1994 Texas Accessibility Standards  
Technical Memorandum

Texas Department of Licensing and Regulation  
Architectural Barriers

TM 00-02

Water Closets – Clear Floor Space  
4.16.2

Fig. 28  
Clear Floor Space at  
Water Closets

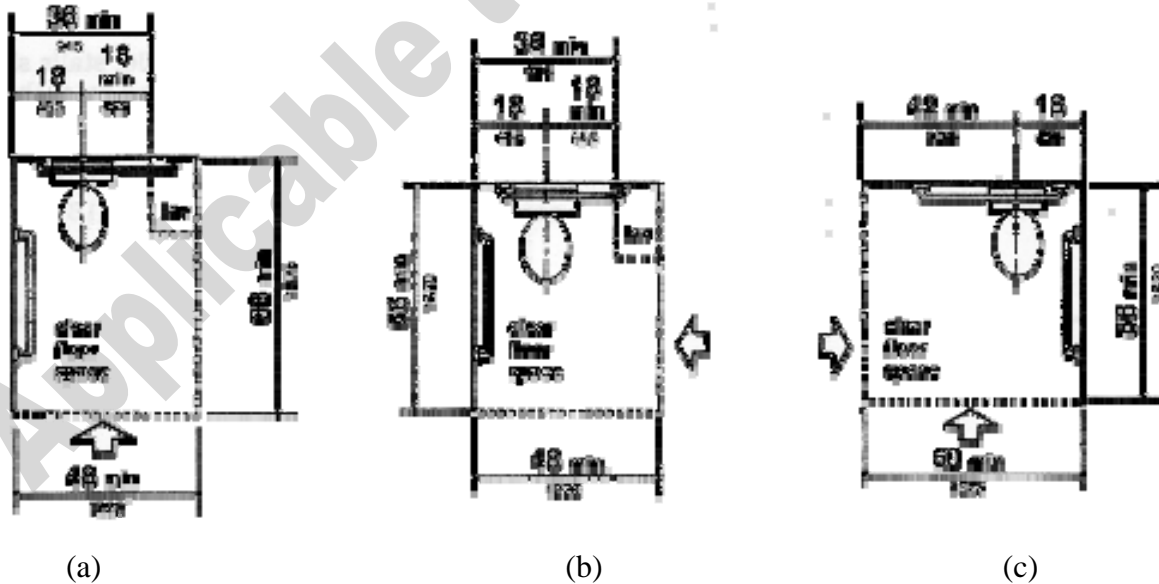
As presented in TAS, Fig. 28 of 4.16 can be misleading. For the purposes of clarification in this technical memorandum, the illustrations below will be referred to as (a), (b) and (c) and Fig. 28 should be considered as shown below. (Dotted lines do not represent walls)

Fig. 28 (c) represents the minimum clear floor spaces required for all water closets not located within toilet stalls. (60-inch wide clear floor space min. is required for all water closets.) Fig 28 (a) and (b) represent the minimum clear floor spaces required for water closets when a lavatory is provided on the same wet-wall adjacent to it and the clear floor space depth required for frontal and side approaches. (Graphics only show half of a lavatory, to it's center-line.)
